Docket Number:	98-AFC-01C
Project Title:	Pittsburg District Energy Facility - Commission Adoption Order (Order No. 99-0817-01)
TN #:	238268
Document Title:	LMEC Petition for Modification Mineralization and Carbon Capture Project—Responses to Data Requests Set 1
Description:	N/A
Filer:	Amanda Cooley
Organization:	Ellison Schneider Harris & Donlan LLP
Submitter Role:	Applicant Representative
Submission Date:	6/17/2021 4:14:58 PM
Docketed Date:	6/17/2021

**LOS MEDANOS ENERGY CENTER (98-AFC-01C)
PETITION FOR MODIFICATION
MINERALIZATION AND CARBON CAPTURE PROJECT
RESPONSES TO CEC STAFF'S DATA REQUESTS SET 1**

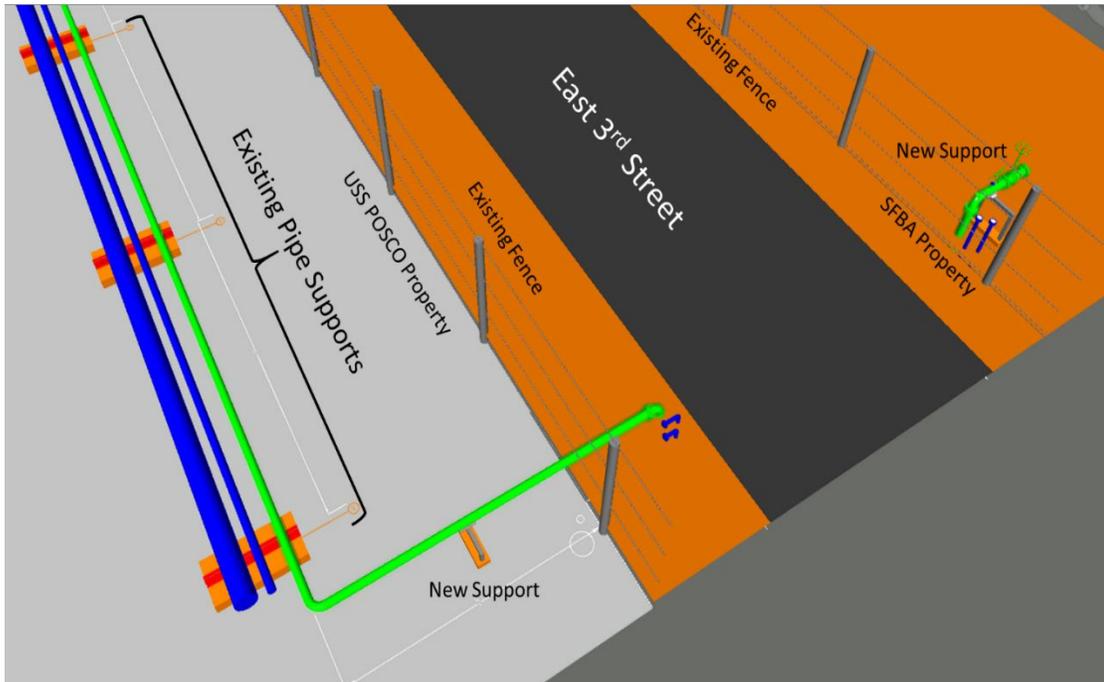
A1. The petition states no ground disturbance will be required for the project.

RESPONSE: Since the filing of the Petition, the pipeline crossing of East 3rd Street has been finalized. The final design routes the pipeline under East 3rd Street, which is a private road. San Francisco Bay Aggregates (“SFBA”) has conducted ground penetrating radar and potholing studies along the road crossing and determined that placing the top of the 8-inch pipe at a depth of 24 inches below the surface of East 3rd Street will provide sufficient clearance over any existing lines. Additional ground disturbance at the USS POSCO property will also be required to install a new pipe support rack. The Project Owner is also proposing to install two additional, 2-inch stainless steel pipe segments to the portions of the work crossing East 3rd Street. These pipes will be capped as there are no current plans to utilize these pipes. However, it is possible that Los Medanos Energy Center (“LMEC”) may provide steam or other process fluid in the future. Installing these pipe segments during the construction for this project will minimize traffic disruptions for any future projects.

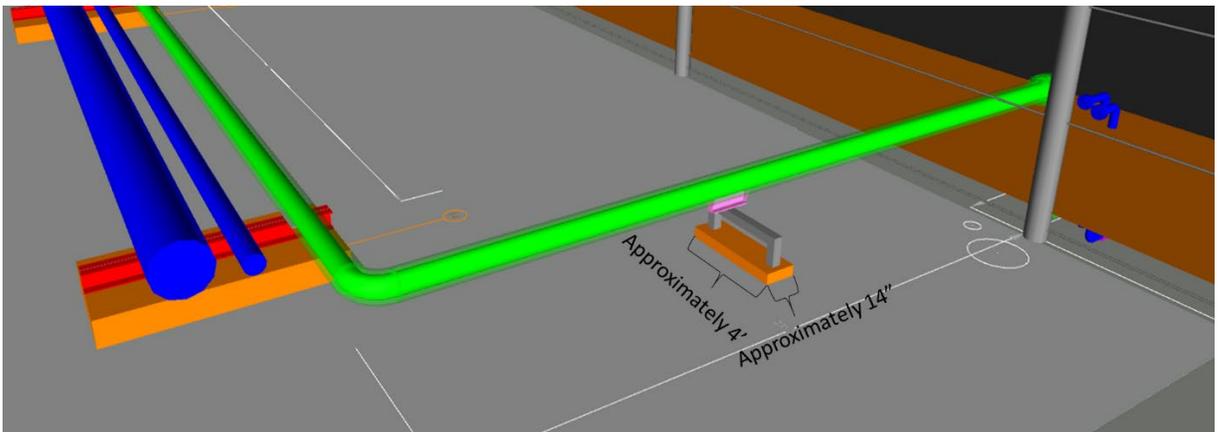
- c) *Please describe how the new sections of pipe rack/supports would be installed and specifically, how that is accomplished without ground disturbance. If ground disturbance is required to install the new sections of pipe rack/supports, please identify the number and extent of horizontal and vertical excavations that would be required to install the pipe racks/supports, the ground surface to which they will be attached or mounted, and*

any below-grade elements that would be required for the installation of the pipe racks/supports.

RESPONSE: Within the LMEC fence line, new sections of pipe will be installed on existing structures using clips and brackets. No additional welding is anticipated for these new attachments. Once the pipe leaves the LMEC fenceline, it will run along LMEC's existing pipe support racks, with the exception of the two new supports described above. The pipe support on USS POSCO property will require ground disturbance of approximately 4 feet in length, 14 inches wide, and installed to the same ground surface as the existing pipe supports. As noted above, in addition to the 8-inch insulated pipe, two additional 2-inch pipes will be installed under East 3rd Street as well. These lines are for future, as-yet undetermined use, and are intended to minimize impacts to the traffic on East 3rd Street, which is a privately owned road.

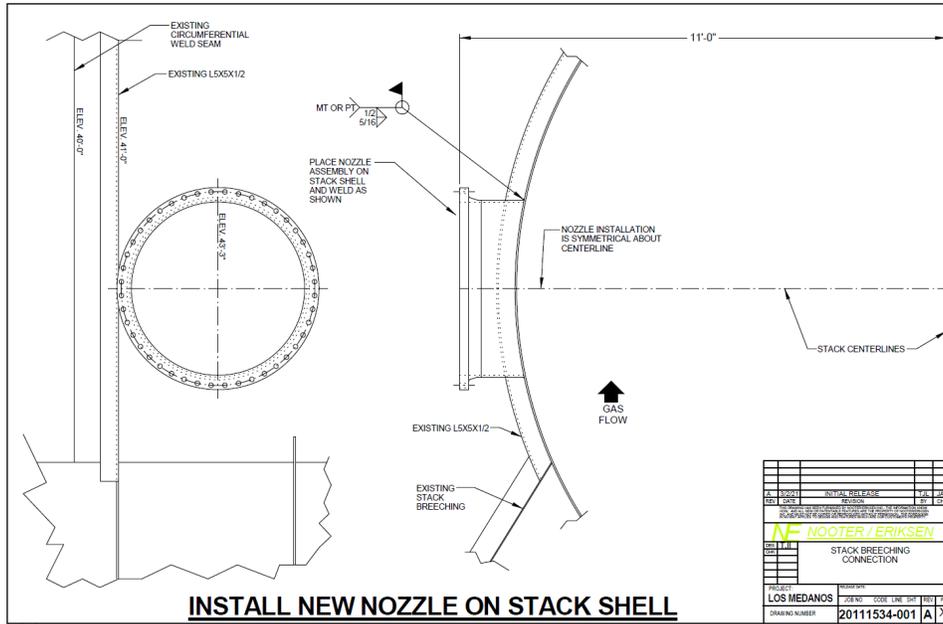
A2. Please provide a figure depicting the new 8-inch pipe where it would interconnect to the stacks and its relationship to the surface at grade or confirm the specifications on Sketch 1. Sketch 1 seems to indicate the connection to be at 34-feet 2-inches above grade and sloping generally at 1/8-inch per foot.

RESPONSE: As shown below, the stack tie-in is a 48-inch nozzle with a centerline approximately 43 feet and 3 inches above grade. Regarding the 1/8-inch sloping per foot, this is a design feature to minimize condensate collection in the pipe. During normal operation, the flue gas temperature is well above the dewpoint and condensation will not be an issue. However, in the event some condensate collects during shutdown, the piping

from the stack to the damper valve (which is for isolation) is designed to be self-draining back to the stack where it will be vaporized by the exiting flue gas.

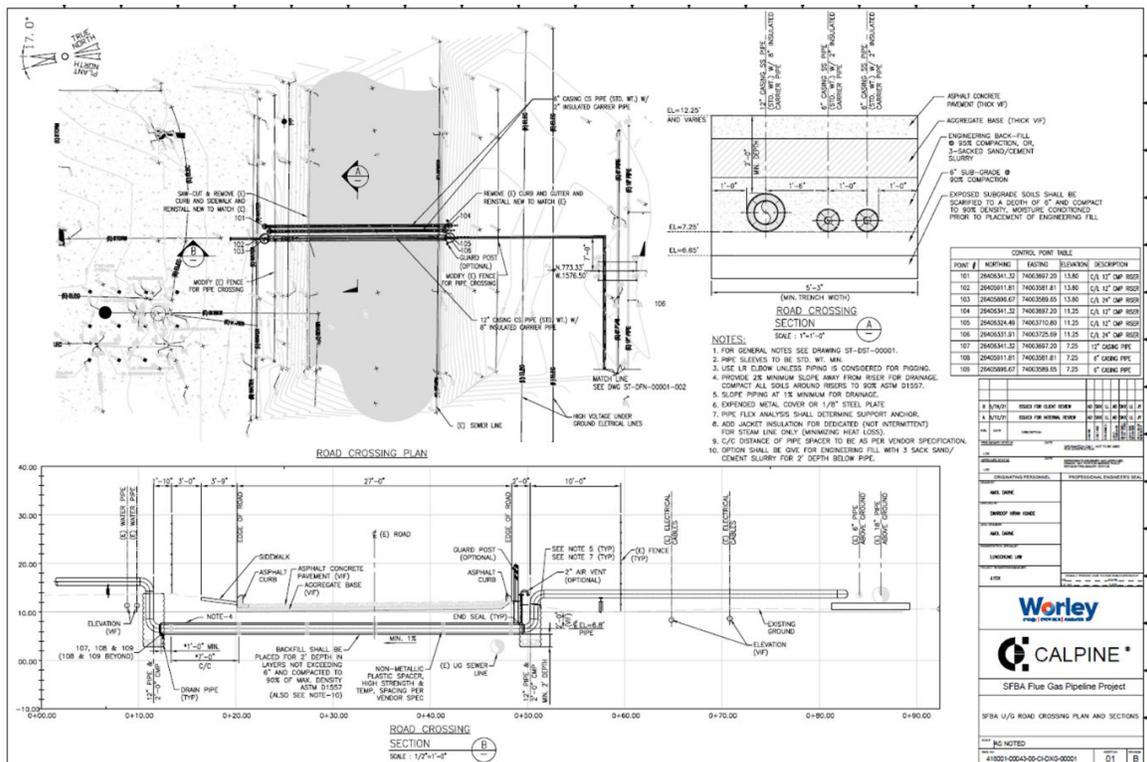
A3. Please provide a site plan on an aerial base that shows the new 8-inch pipe connection at the stack and the entirety of the pipe line to the connection at the adjacent property.

A4. Please describe the ground disturbance and pipeline connection on San Francisco Bay Aggregate's property required to accomplish the CO2 removal.

RESPONSE: There is no ground disturbance associated with the Carbon Capture and Mineralization Project. Equipment is skid mounted with no below grade construction of facilities or pipelines, construction of new foundations, or construction of new buildings. The pipeline support on the SFBA property will be located on an existing concrete pad.
